#175-21

**PUBLIC HEARING MEMORANDUM**

SUBJECT: **Petition #175-21**, for a SPECIAL PERMIT/SITE PLAN APPROVAL to allow a for-profit educational use, to alter a non-conforming non-accessory parking facility, to allow the parking requirements to be met off-site, to allow parking within the side and rear setbacks and within five feet of the street, to allow parking within five feet of dwelling units, to waive the minimum parking stall width and depth, to waive the minimum driveway width for one-way traffic, to waive perimeter screening requirements, to waive interior landscaping requirements and to waive lighting requirements at 60, 66-68 Austin Street, Ward 2, Newtonville, on land known as Section 24 Block 09 Lots 07 and 09, containing approximately 35,616 sq. ft. of land in a district zoned BUSINESS USE 5. Ref: Sec. 7.3.3, 7.4, 4.4.1, 6.3.14.B.2, 7.8.2.C.2, 5.1.16.A, 5.1.13, 5.1.8.A.1, 5.1.8.A.2, 5.1.8.B.1, 5.1.8.B.1, 5.1.8.D.1, 5.1.9.A, 5.1.9.B, 5.1.10 of the City of Newton Rev Zoning Ord, 2017.

**60 Austin Street**

### Proposed Site Plan

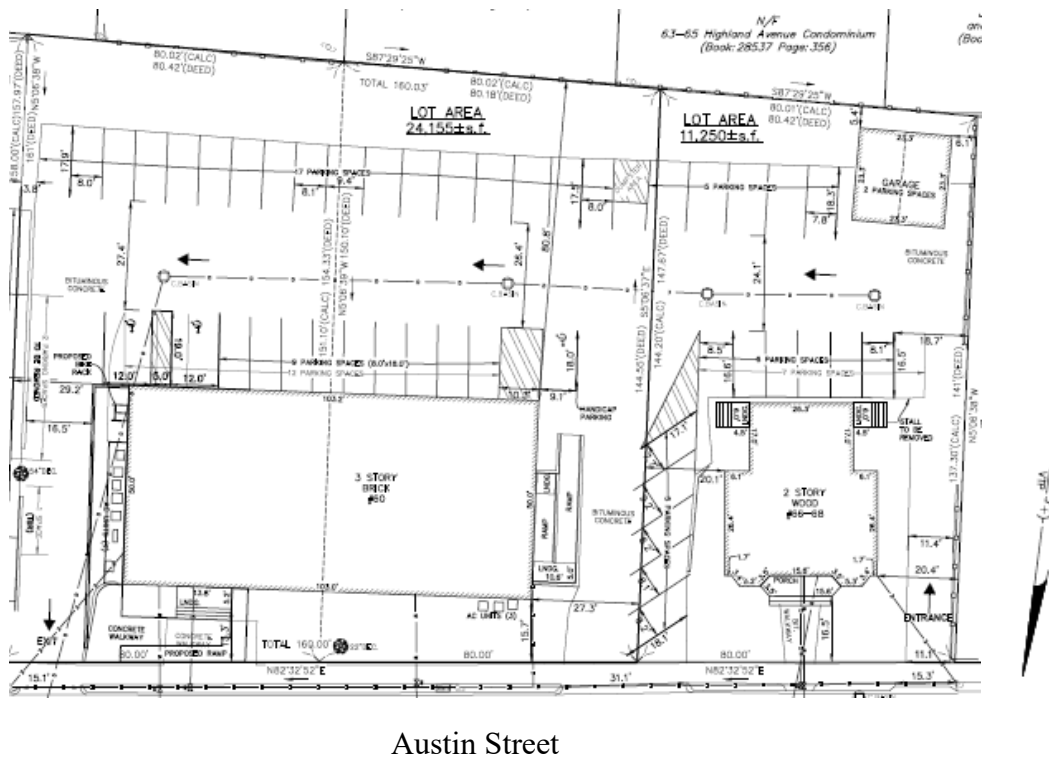
The petitioner proposes to utilize the western access point, to the right of the two-family dwelling, as a one-way entrance to the site. This driveway is 11.4 feet wide, where 12 feet is required, thus a special permit is required. The access aisle then widens to 18.7 feet before the left-hand turn to access the remaining parking and site. The drive aisle between the two rows of parking ranges from 24.1 feet to 27.4', meeting the requirement for one way traffic. Egress from the site is located at the eastern boundary

of 60 Austin Street, and the drive aisle is proposed at 16.5 feet wide, meeting the 12-foot requirement. The petitioner should clarify the purpose of the middle driveway, any potential pavement markings, or directional cues, and how traffic will be directed from vehicles accessing the site from Austin Street at the middle driveway.

The petitioner is also seeking to locate parking within a required setback distance, within five feet of the street, and within five feet of a building containing dwelling units. The petitioner is seeking to locate five parking stalls within five feet of the two-family dwelling. Parking is also proposed within the side and rear setbacks, and within five feet of the street. The petitioner should submit plans with the setbacks dimensioned to better determine exactly how many stalls are within the setbacks.

The petitioner is also proposing bike parking along left elevation for 60 Austin Street. The petitioner should provide more details on the bike rack and how many bikes the rack will accommodate.
